R20AW

ADDITIONAL FINAL NOTICE

DATE: March 3, 2022
TO: Blue Bird Owners
Subject: R20AW – Drag Link Castle Nut Torque Confirmation

SUBJECT: R20AW – Drag Link Castle Nut Torque Confirmation

Fig. 1

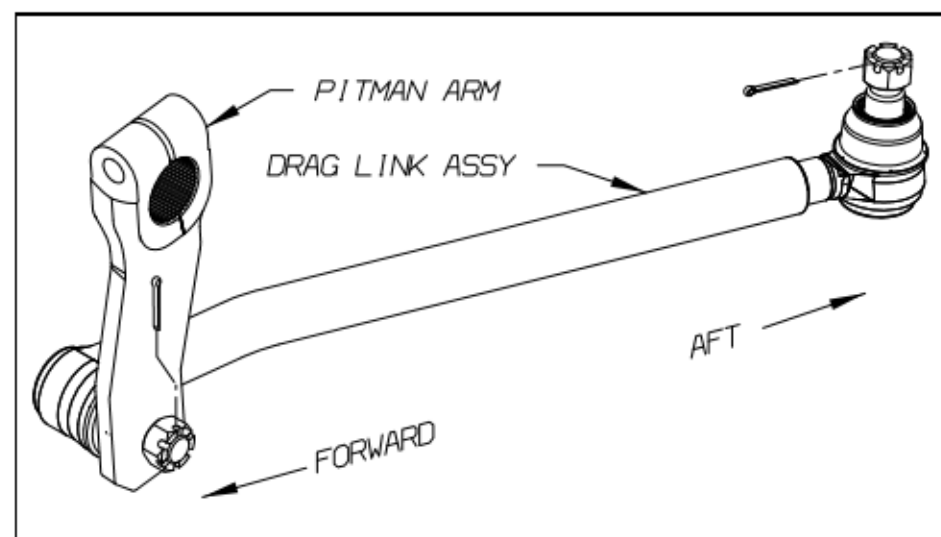
Issue: The castle nuts on both ends of the drag link assembly may not have been installed according to manufacturer's installation specifications.

1. Check the taper stud joint at both ends of the drag link to ensure the joint is tight. This can be completed by applying both vertical and horizontal pressure to the drag link. (Push and Pull) **No movement is allowed.**
2. If movement is found, the drag link will need to be removed for inspection of the machined surfaces and stud threads. No wear or oblong hole is allowed.
3. Replace any components that are found to be worn or damaged.
4. If the taper joints are tight move to step (1) of the instructions.

1. Park bus on a level surface, apply parking brake, switch engine off, remove ignition key and chock wheels.
2. Remove cotter pin from ball stud on forward (pitman arm) end of drag link. (Fig. 1)
3. Torque castle nut on drag link ball stud to 120 ft-lbs.
4. Remove cotter pin from ball stud on aft (steer arm) end of drag link. (Fig. 1)
5. Torque castle nut on drag link ball stud to 120 ft-lbs.
6. Install cotter pins.
7. If castle nut slot for cotter pin does not line up with through hole in each ball stud, tighten castle nut until next slot aligns with through hole. Install cotter pin and bend-over pin tails. **WARNING: Do NOT loosen castle nut to line up slot with through hole in ball stud. Always tighten castle nut to align slot with through hole.**
